S/AR/2010/341

Proposal: Outline application with some matters reserved for the demolition of derelict 2-storey office building & erection of 8 no. 2-bed flats & 6 no. 1-bed flats with ground floor parking, bin & cycle storage & children play area.

Site: Formerly Westside Supplies 17/18 Durban Road, Bognor Regis, West Sussex PO22 9RY.
BR/341/10/

Southern Water MapGuide Browser

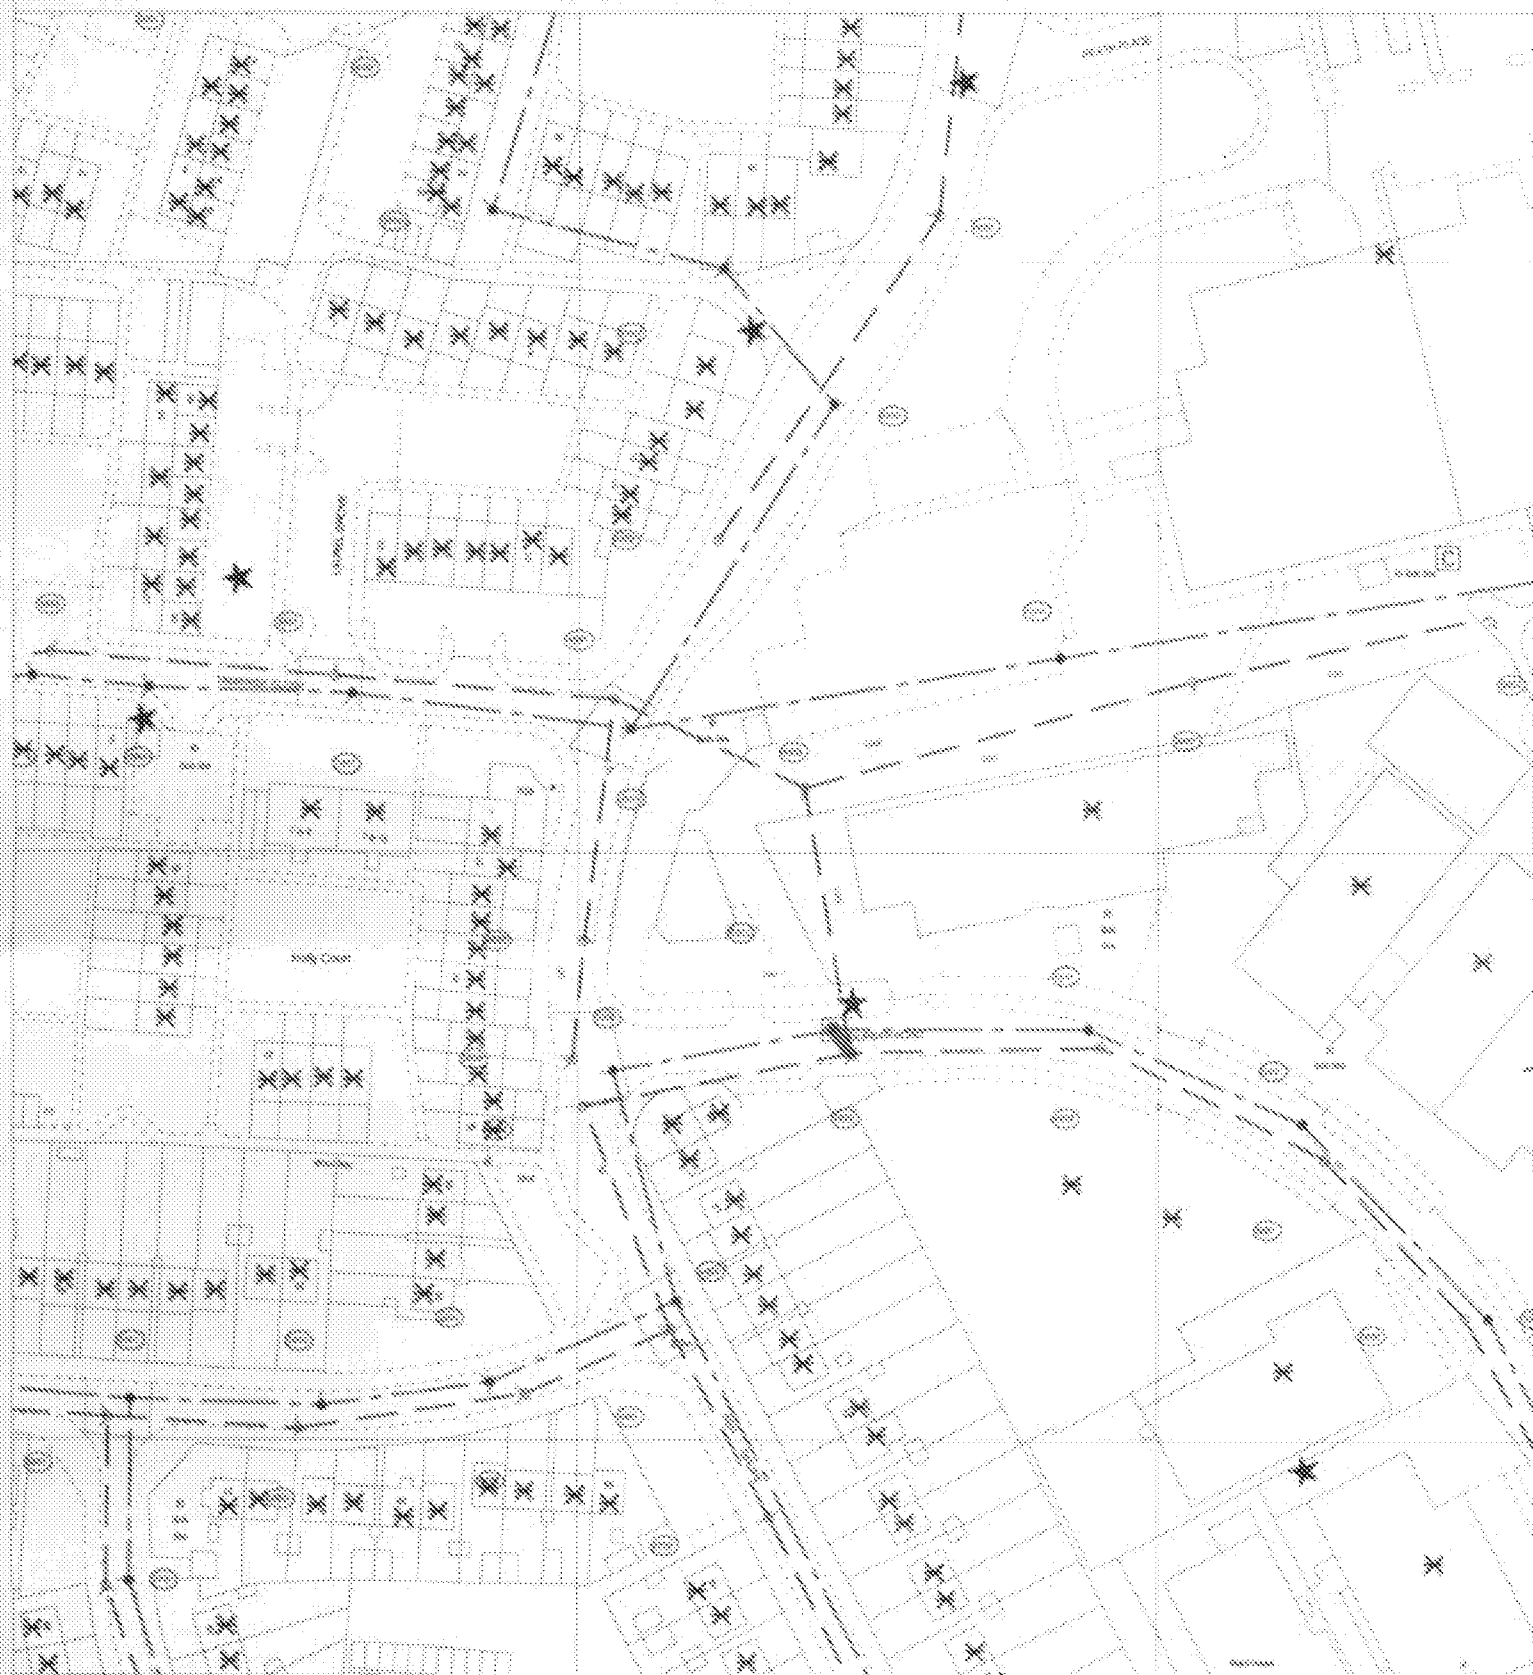
Please find attached a plan of the sewer records showing the approximate position of a public sewer in the close vicinity of the site. The exact position of the public sewers must be determined on site by the applicant before the layout of the proposed development is finalised. Please note:

- No development or new tree planting should be located within 4 metres of the public sewer.
- No new soakaways should be located within 5m of a public sewer.
- All existing infrastructure should be protected during the course of construction works.

In order to protect drainage apparatus, Southern Water requests that if consent is granted, a condition is attached to the planning permission. For example "The developer must advise the local authority (in consultation with Southern Water) of the measures which will be undertaken to protect the public sewers, prior to the commencement of the development".
